**Notification subject:** ERRATA - PIC24FJ256GB110 Family Silicon/Data Sheet Errata

## Product Change Notification - SYST-22TJFL941

## PIC24FJ256GB110 Family Silicon Errata and Data Sheet Clarification

**FIGURE 2-3 FREQUENCY vs. ESR PERFORMANCE FOR SUGGESTED VCAP**

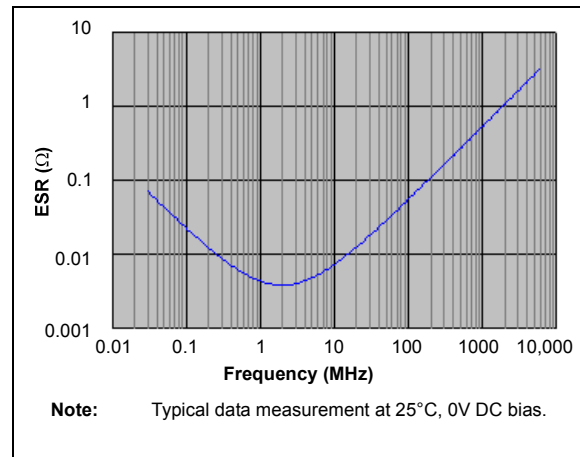
Designers may use [Figure 2-3](#) to evaluate ESR equivalence of candidate devices.

When the regulator is disabled, the VCAP/VDDCORE pin must be tied to a voltage supply at the VDDCORE level. Refer to **Section 29.0 “Electrical Characteristics”** for information on VDD and VDDCORE.

**FIGURE 2-4 DC BIAS VOLTAGE vs. CAPACITANCE CHARACTERISTICS**

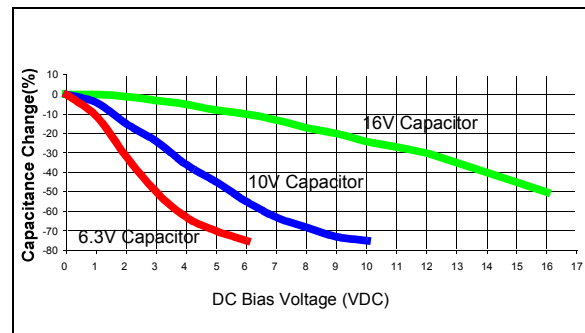
In addition to temperature tolerance, the effective capacitance of large value ceramic capacitors can vary substantially, based on the amount of DC voltage applied to the capacitor. This effect can be very significant, but is often overlooked or is not always documented.

A typical DC bias voltage vs. capacitance graph for 16V, 10V and 6.3V rated capacitors is shown in Figure 2-4.

When selecting a ceramic capacitor to be used with the internal voltage regulator, it is suggested to select a high-voltage rating, so that the operating voltage is a small percentage of the maximum rated capacitor voltage. For example, choose a ceramic capacitor rated at 16V for the 2.5V core voltage. Suggested capacitors are shown in Table 2-1.

**FIGURE 29-1: PIC24FJ256GB110 FAMILY VOLTAGE-FREQUENCY GRAPH (INDUSTRIAL)**

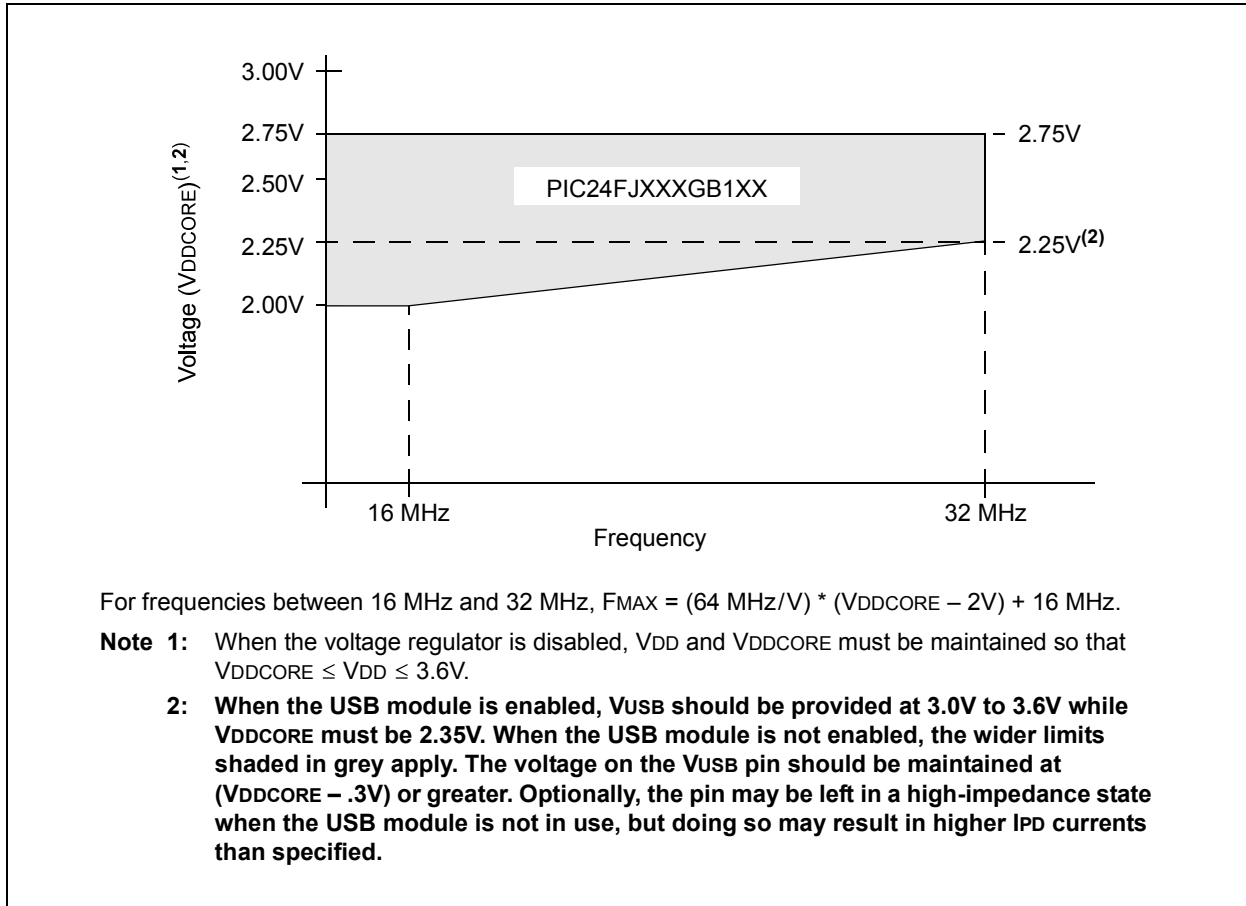
Figure 29-1 (“PIC24FJ256GB110 Family Voltage-Frequency Graph”) is amended by adding an additional footnote. The updated figure is shown below (changes in **bold**; bold in original removed for clarity).
